CITY OF FRANKLIN
PLAN COMMISSION MEETING*
FRANKLIN CITY HALL COUNCIL CHAMBERS
9229 W. LOOMIS ROAD, FRANKLIN, WISCONSIN
AGENDA
THURSDAY, MARCH 9, 2023, 7:00 P.M.

1. **JILLY’S CAR WASH FACILITY DEVELOPMENT.** Special Use, Site Plan and Certified Survey Map applications by Jonathan J. Zimmerman, President of Jilly’s, LLC (Devo Properties/Rawson LLC, property owner), to allow for the development of a single-story building housing offices and a car wash facility (approximately 6,373 square feet including office, car wash bay, mechanical equipment and employee booth), with adjacent parking for vacuum stalls as well as general parking, three separate pay stations, landscaping and lighting, with hours of operation Monday through Saturday, from 7:00 a.m. to 8:00 p.m. and on Sunday, from 8:00 a.m. to 7:00 p.m. (stormwater facilities will be shared with the adjoining Sendik’s Food Market property, using an existing pond to the north of these parcels), on vacant property (1.4910 acres) proposed to be divided into three lots (the car wash facility will be located on the future Lot 1), located at 5450 West Rawson Avenue, such property being zoned M-1 Limited Industrial District and OL-2 General

CERTIFIED SURVEY MAP No. _____

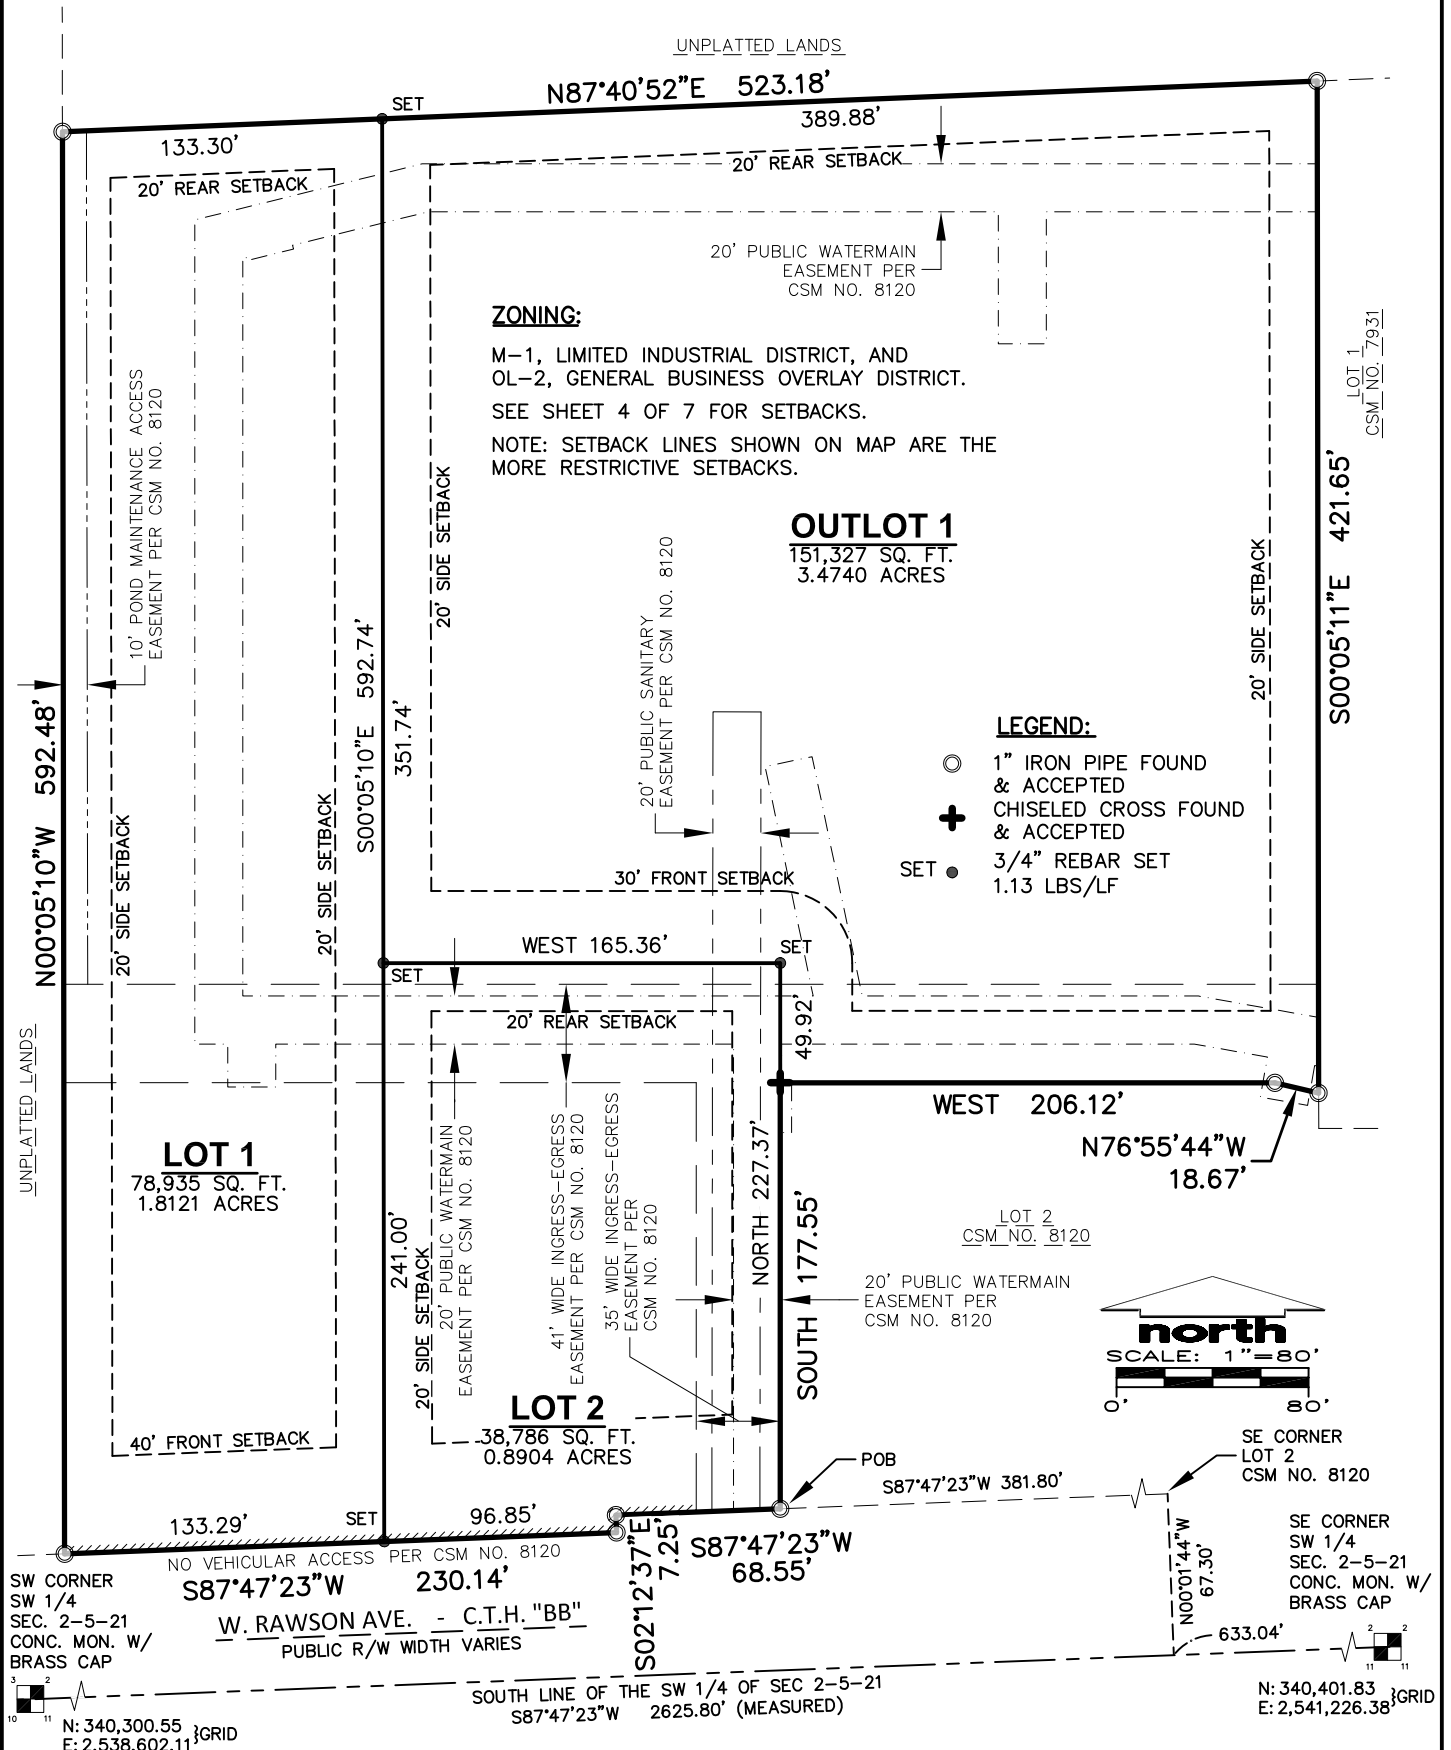
RESPONSE: Acknowledged.
6. Please depict zoning setbacks and building lines on the Certified Survey Map (§15-7.0702.B).
RESPONSE: Acknowledged. The CSM has been updated.

PROPOSED EASEMENT VACATION DETAILS

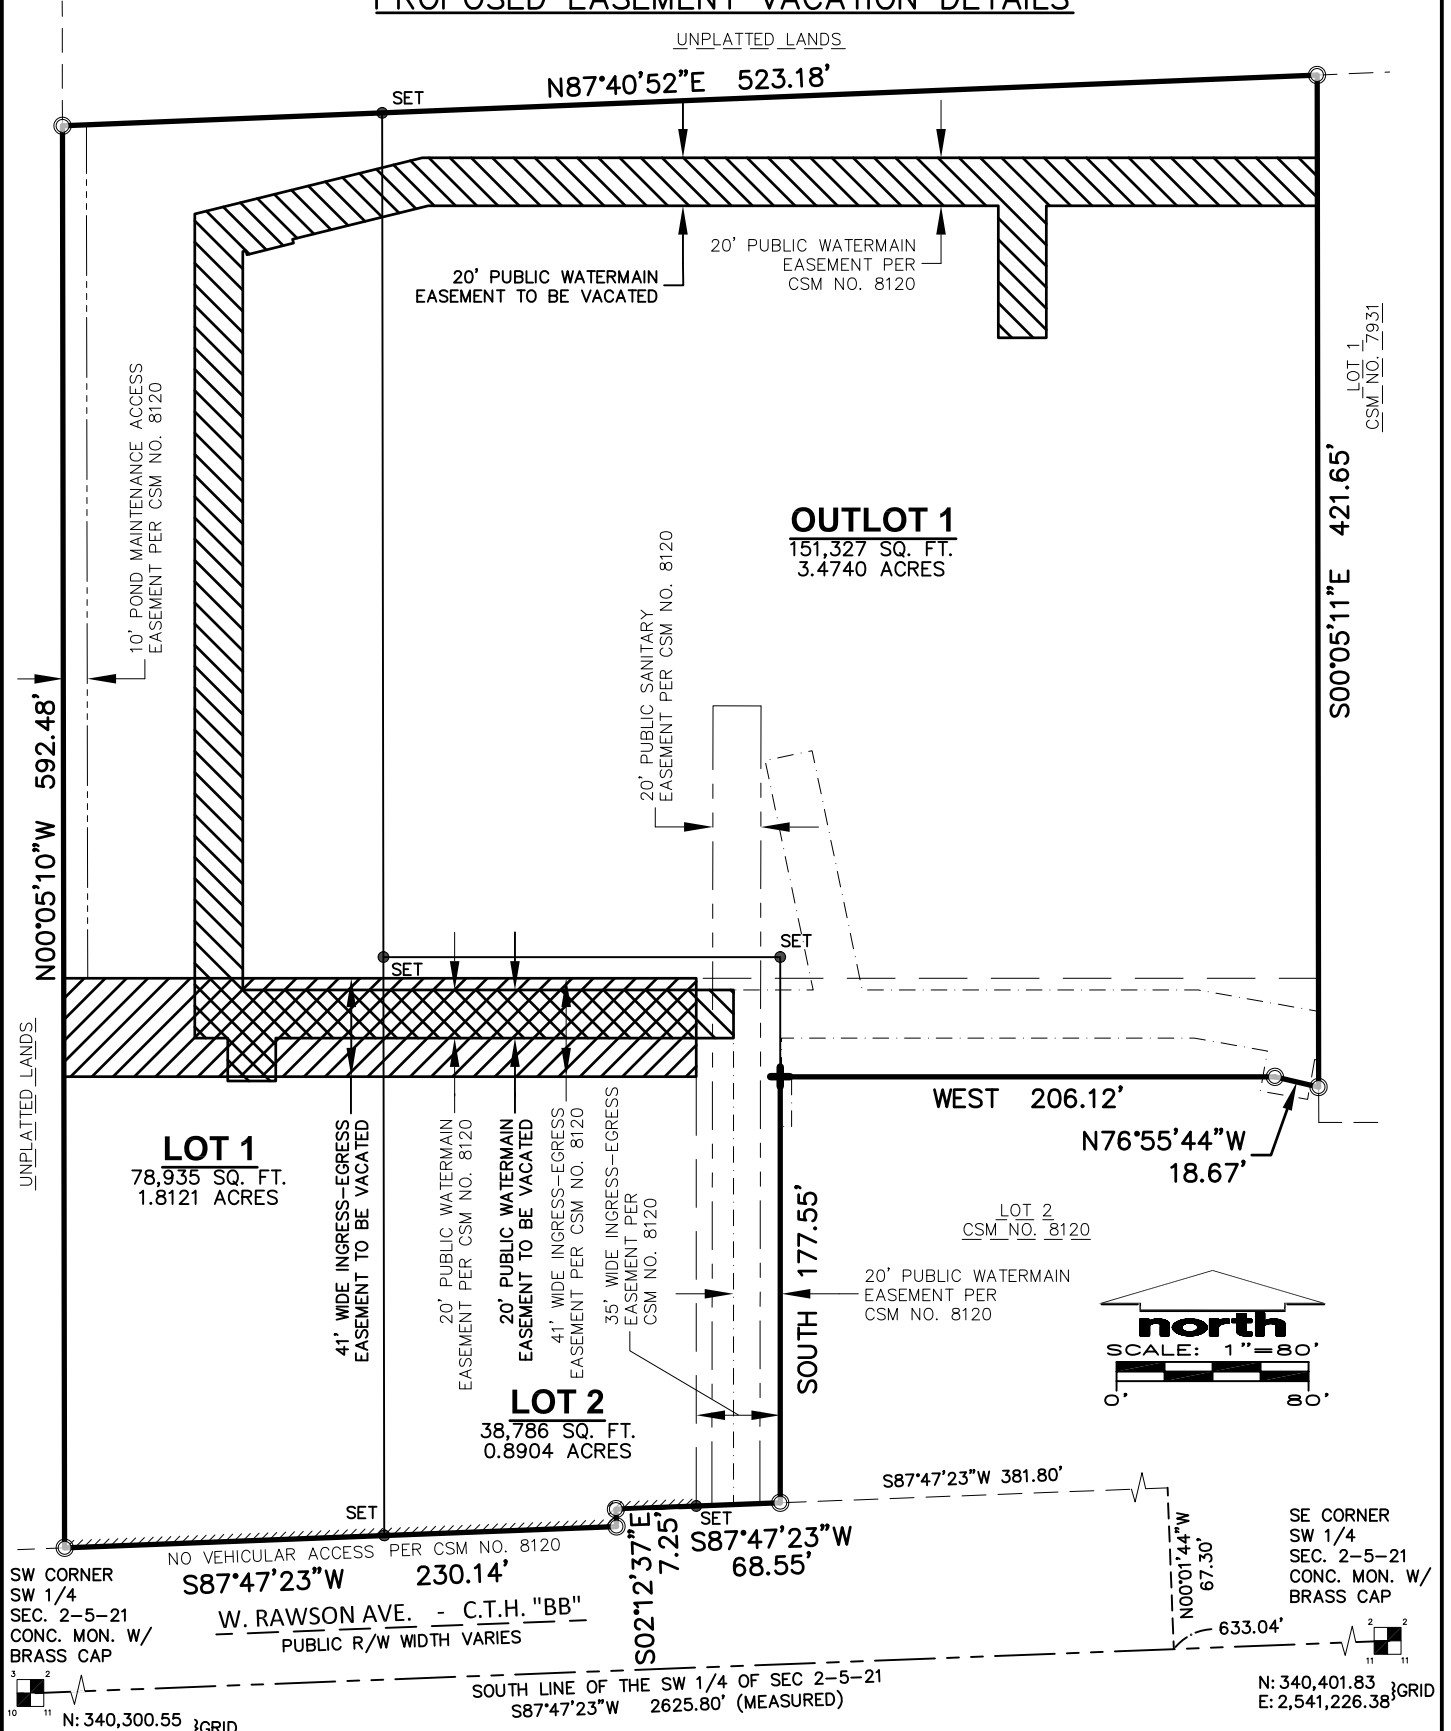
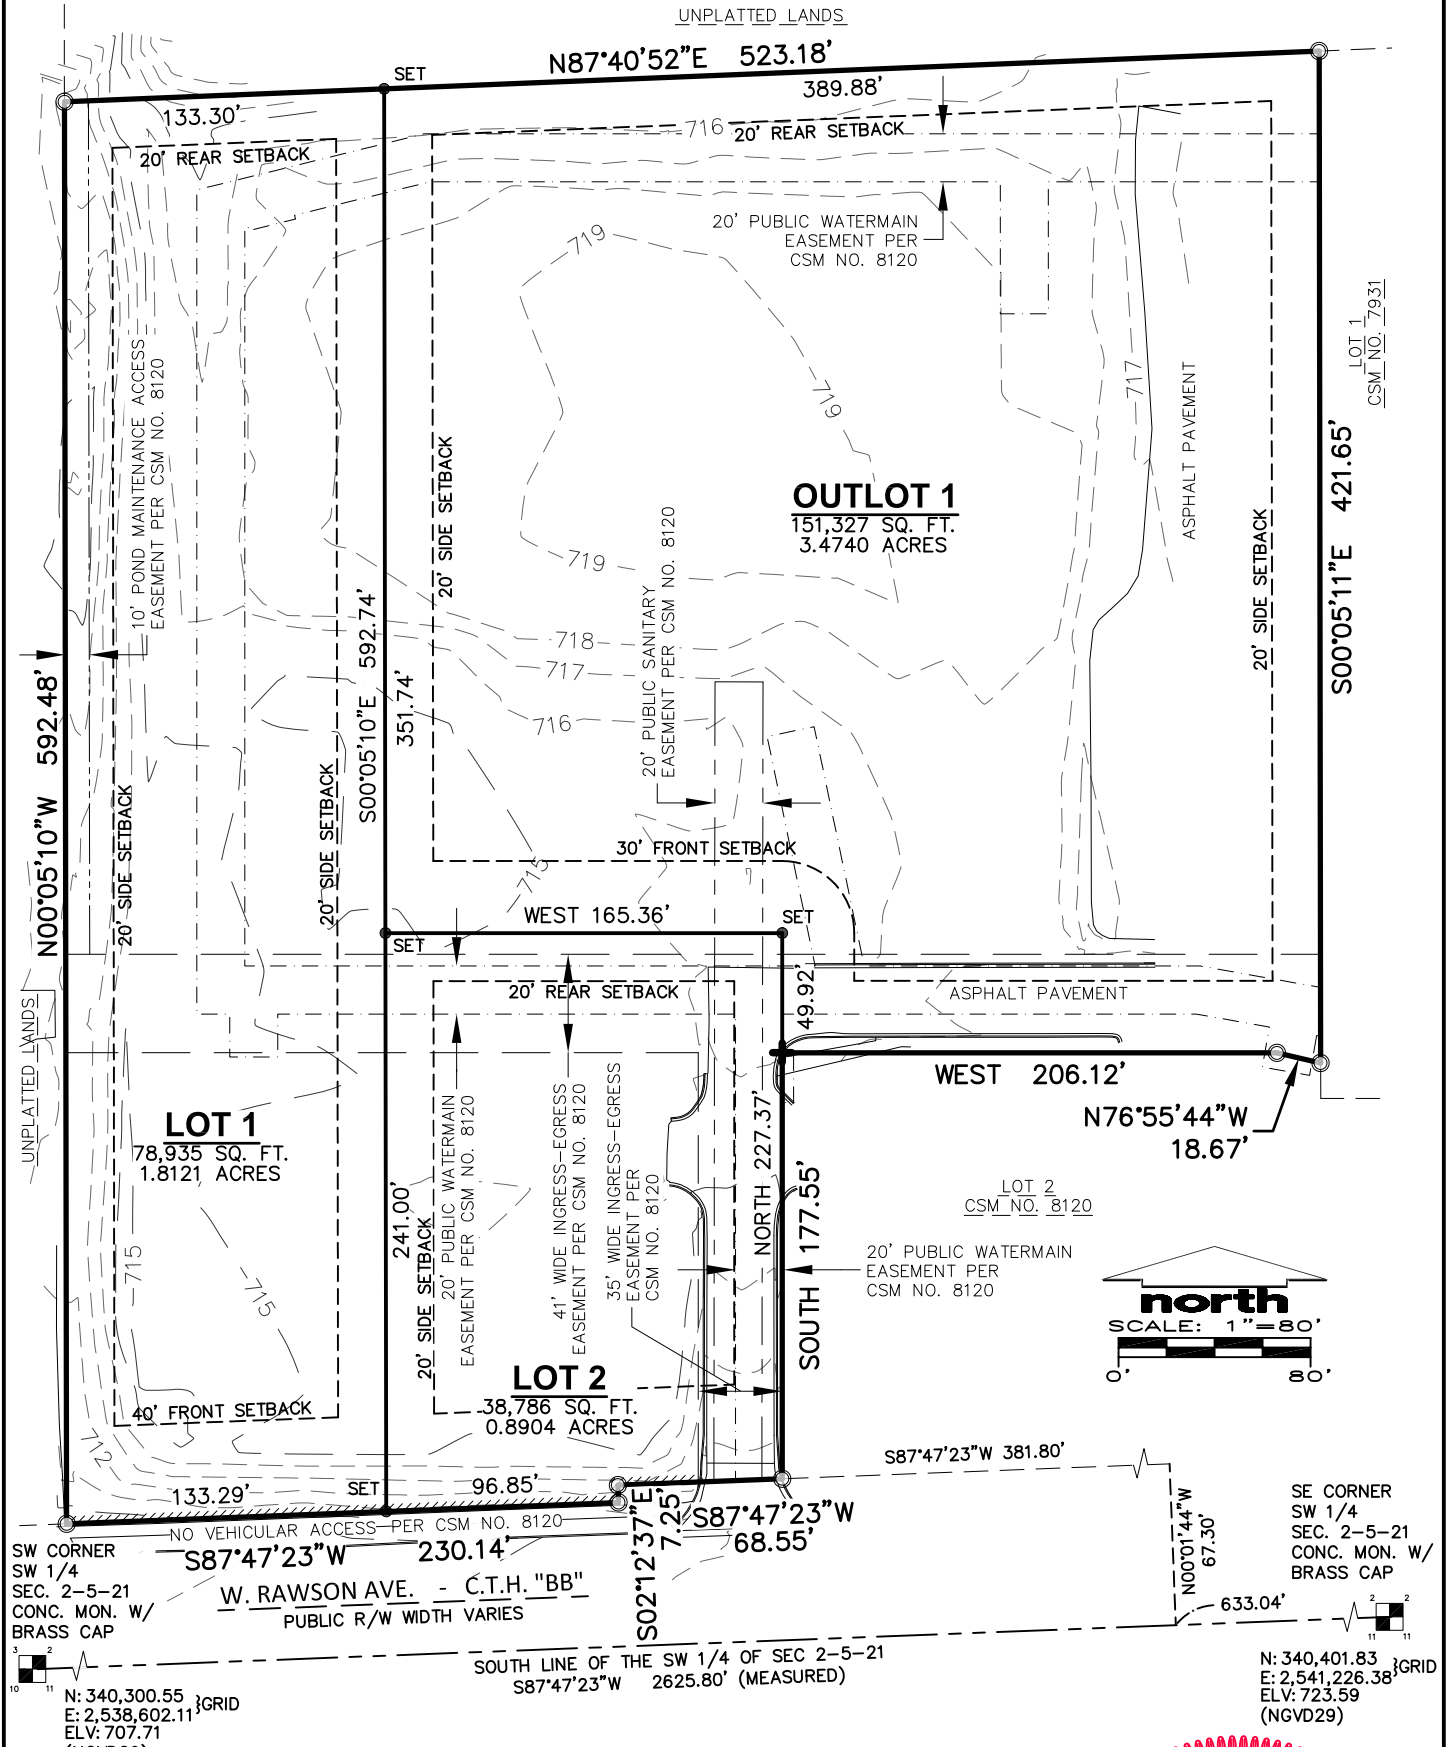
7. The applicant shall comply with any requirements of Fire Department safety standards and code.
8. The applicant shall provide a document vacating the 41 foot wide ingress-egress easement and the 20 foot wide public water main easement, and a new access easement for the private road.
